Access Compliance Report Public Rights-of-Way (Curb Ramps)

Main Street: **BROWNING_AVE** Cross Street: **RED_MILL_CIR** Location: **NW**

ADA ID: **RPAT211012111204** Ramp Type: **Type 3 - Combination 1** Initial Pass/Fail: **Fail** Overall Compliance: **No** Severity Score: **35**

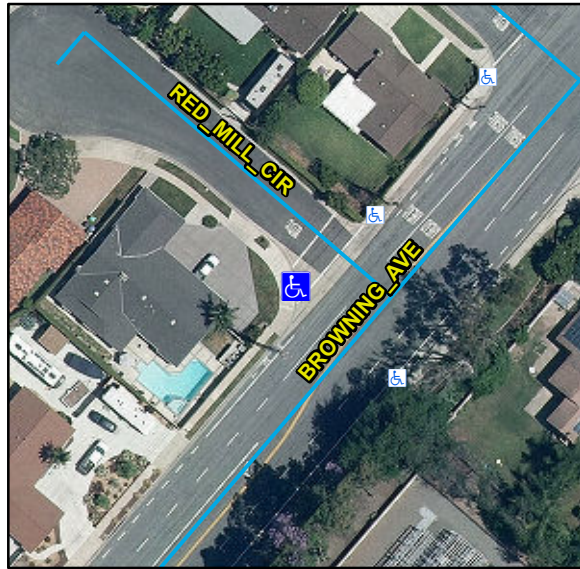
Compliance	Description	Data	Compliance	Description	Data
N/A	Ramp Length LT (in)	87	N/A	Ramp Length RT (in)	66
No	Ramp Width LT (in)	45	No	Ramp Width RT (in)	45
Yes	Ramp Run Slope LT (%)	2.3	Yes	Ramp Run Slope RT (%)	7.4
No	Ramp Cross Slope LT (%)	4.6	No	Ramp Cross Slope RT (%)	2.8
N/A	Ramp Length (in)	47	N/A	Flare Type LT	
Yes	Ramp Width (in)	63			N/A
No	Ramp Run Slope (%)	12.6	N/A	Flare Slope LT (%)	N/A
Yes	Ramp Cross Slope (%)	1.3	N/A	Flare Traversable LT	N/A
N/A	Landing Present	N/A	N/A	Flare Type RT	
N/A	Landing Length (in)	N/A			N/A
N/A	Landing Width (in)	N/A	N/A	Flare Slope RT (%)	N/A
N/A	Landing Run Slope (%)	N/A	N/A	Flare Traversable RT	N/A
N/A	Landing Cross Slope (%)	N/A	N/A	DWS Provided	N/A
N/A	Landing Movement Obstructed?	N/A	N/A	DWS Contrast	N/A
	Landing Movement Type	N/A	N/A	DWS Length (in)	N/A
N/A	Landing Shared	N/A	N/A	DWS Full Width	N/A
N/A	Clear Space	Yes		DWS Offset Type	N/A
N/A	Clear Space To Crosswalk (in)	N/A	N/A	DWS Offset Left (in)	N/A

Remove & Replace Curb Ramp With Two New Directional Ramps or Equivalent.

R304.2.2, R204.3, R304.5.1, R304.5.3, STD 1115
